Subject: Phase III Bond Release, PacifiCorp, Deer Creek Mine, Left Fork of Rilda Canyon,

C/015/0018, Task #5775

2.33 acres in the Left Fork of Rilda Canyon
Phase III Bond Release
PacifiCorp
Deer Creek Mine
C/015/0018
Emery County, Utah

Technical Analysis and Findings Utah Coal Regulatory Program

16.a Roads: Construction, Maintenance, Surfacing

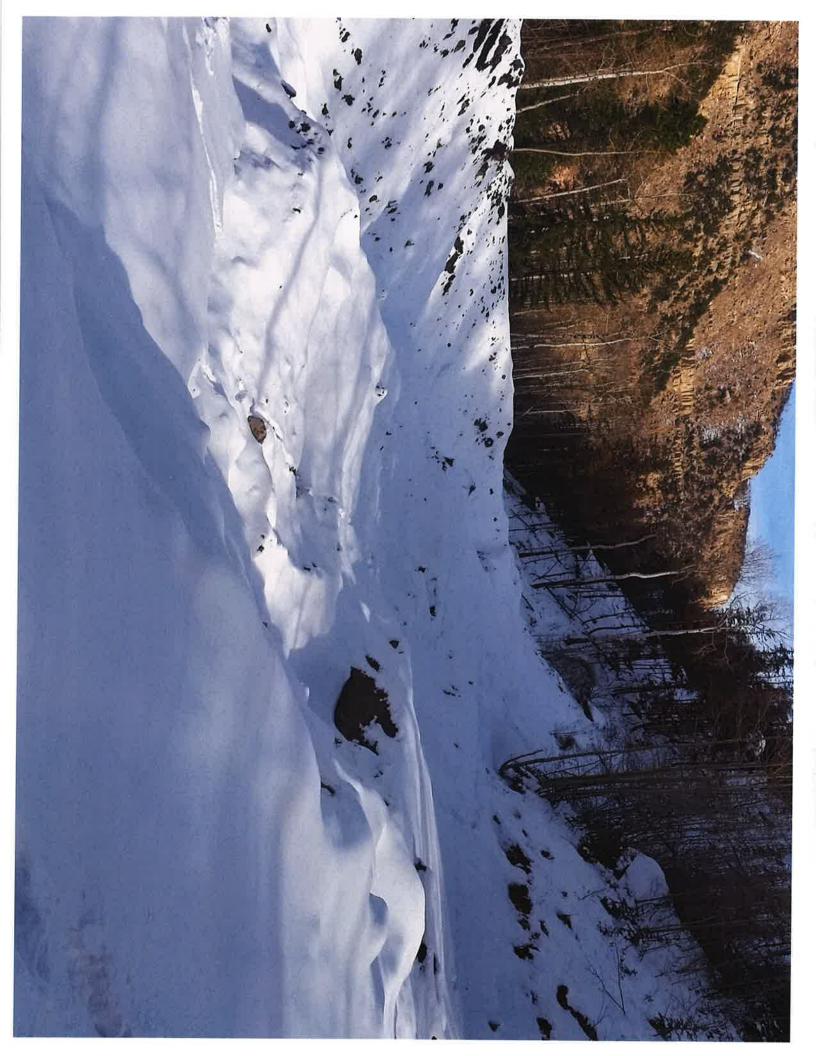
The road leading to the South Fork area will be left for access to the Forest Services catchment basin. The Forest requested that the road be left and it would be included in the 2.33 acre bond release.
